PLANNING

Project **7 Warwick Court**

Drawing Title **Demolition & Proposed Basement Plan**

Drawing No. **P_02** Rev. **D**

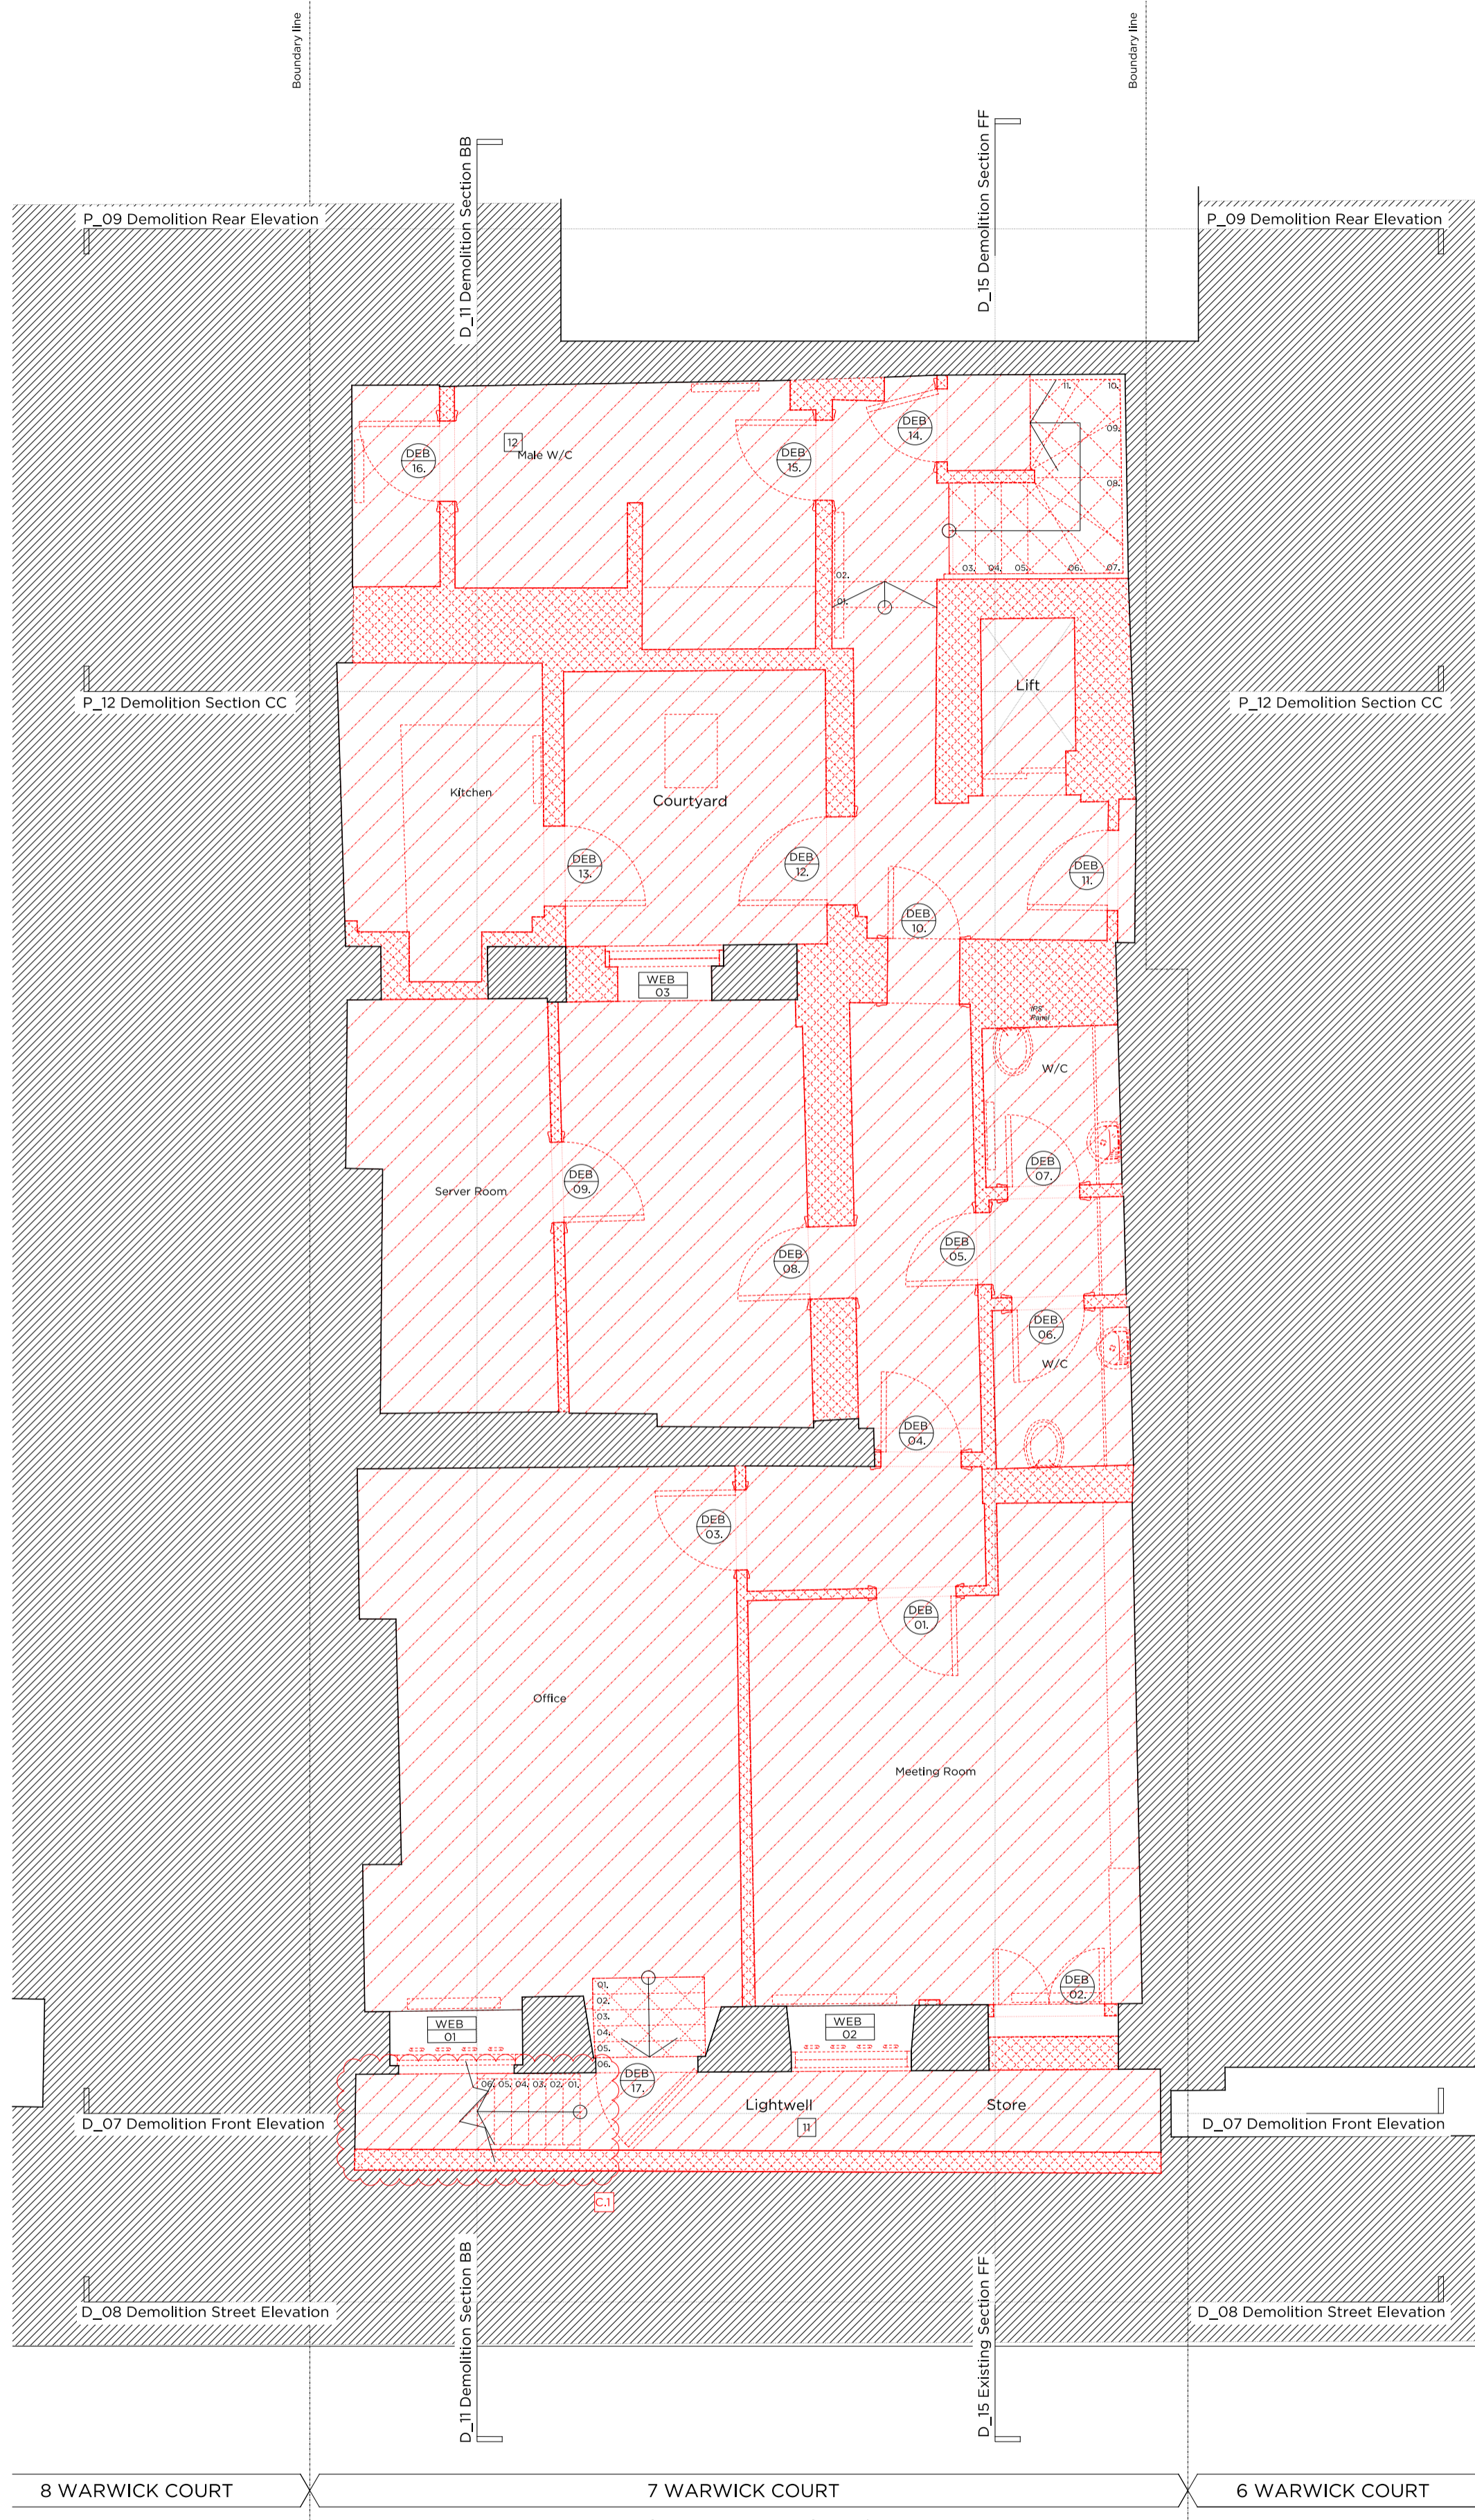
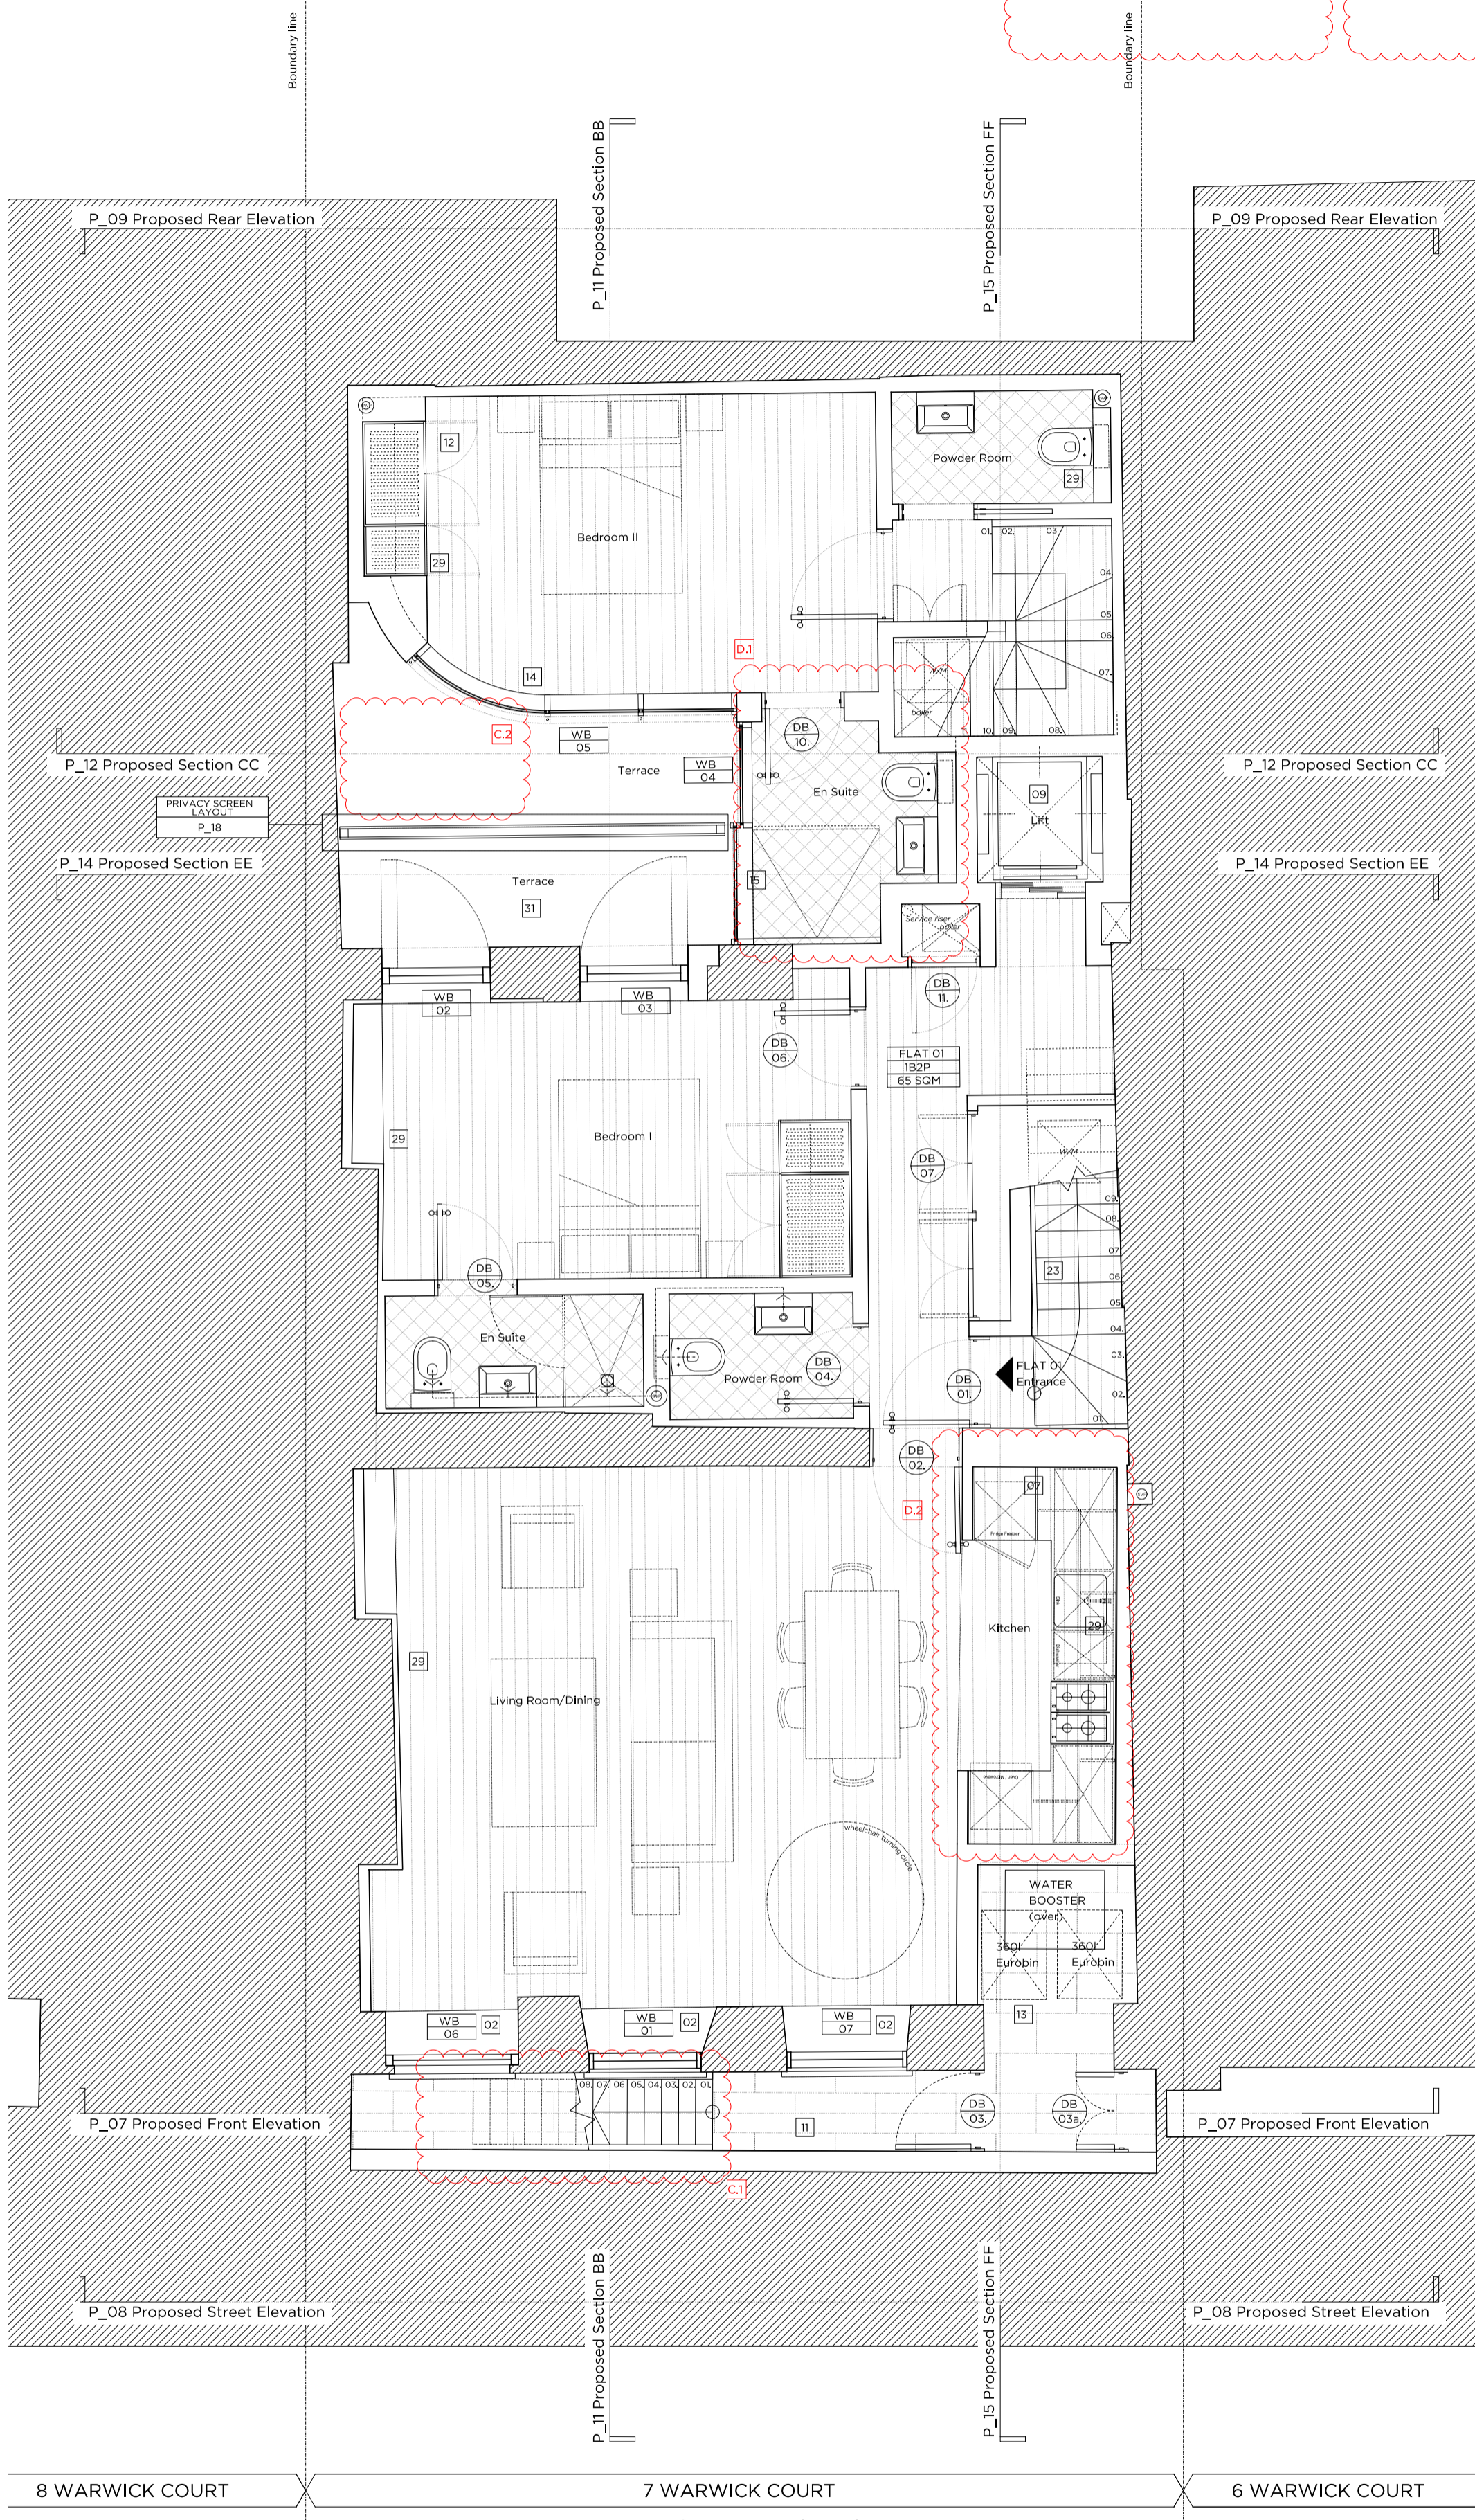
- B. Revision Notes:**
- 11 Proposed Ensuite layout updated. Door leading to terrace removed.
 - 12 Proposed Kitchen and Dining room layout updated.
- C. Revision Notes:**
- 21 Railings and lightwell stair to remain in existing position.
 - 22 Removal of single fan condenser.
